CITY OF CODY
PLANNING, ZONING, AND ADJUSTMENT BOARD
TUESDAY SEPTEMBER 10, 2019
CITY HALL COUNCIL CHAMBERS @ 12:00 NOON

**CITY OF CODY
PLANNING, ZONING AND ADJUSTMENT BOARD
STAFF REPORT**

MEETING DATE:	SEPTEMBER 10, 2019	TYPE OF ACTION NEEDED	
AGENDA ITEM:		P&Z BOARD APPROVAL:	
SUBJECT:	PRELIMINARY PLAT OF THE BEACON HILL MINOR SUBDIVISION— A 3-LOT SUBDIVISION. SUB 2018-04	RECOMMENDATION TO COUNCIL:	X
PREPARED BY:	TODD STOWELL, CITY PLANNER	DISCUSSION ONLY:

PRELIMINARY PLAT-REV.
BEACON HILL MINOR
SUBDIVISION

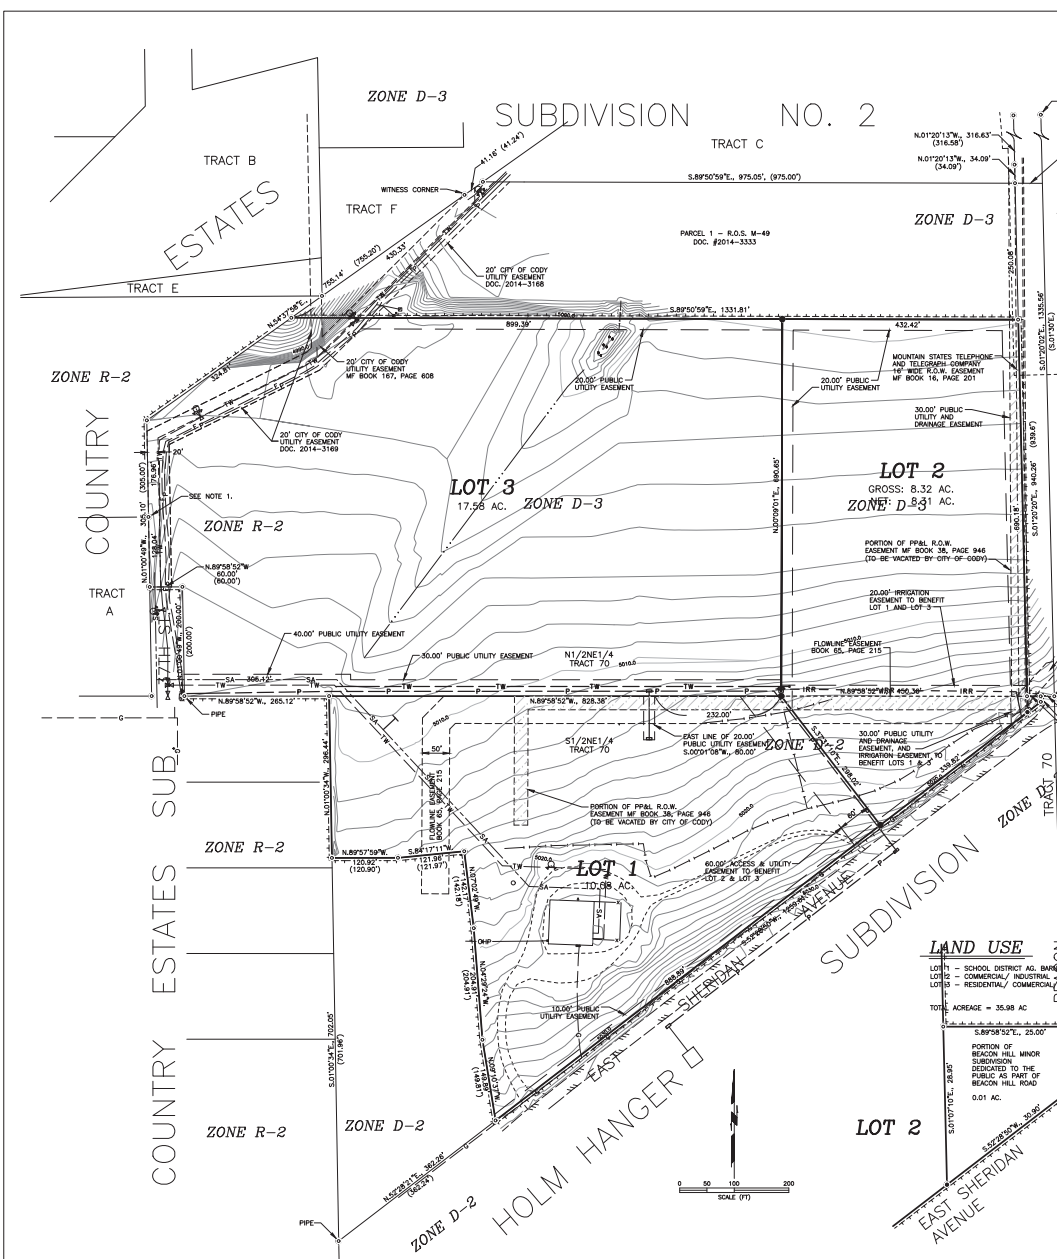
With the waiver of frontage improvements along Beacon Hill Road and Sheridan Avenue, the standard improvement district language needs to be added to the "Certificate of Owner" on the final plat (applicable to Lots 1 and 2).

1. Include a note referencing that the lot owners are responsible for specific subdivision improvements as outlined in the Beacon Hill Minor Subdivision Development Agreement on file with the City of Cody.
2. Include a note that the owner of Lot 1 agrees to dedicate the 60' access easement as public right-of-way at no cost to the City upon the request of the City.
3. Add the improvement district language noted above.
4. Remove "East" from the Sheridan Avenue label.
5. Correct the legend and perimeter lot corners to show placement of brass caps, as required by City of Cody Code 11-5-1(B)(3).

6. Make the following additions/changes to the final plat:
 - a. Add the standard improvement district language to the "Certificate of Owner". (Applicable to Lots 1 and 2. Optional for Lot 3.)

- b. Include a note that the lot owners are responsible for specific subdivision improvements as outlined in the Beacon Hill Minor Subdivision Development Agreement on file with the City of Cody.

- c. Include language in the "Certificate of Owner" that the owner of Lot 1 agrees to dedicate the 60' access easement as public right-of-way at no cost to the City upon the request of the City.

- d. Remove "East" from the Sheridan Avenue label.
 - e. Correct the legend and perimeter lot corners to show placement of brass caps, as required by City of Cody Code 11-5-1(B)(3).
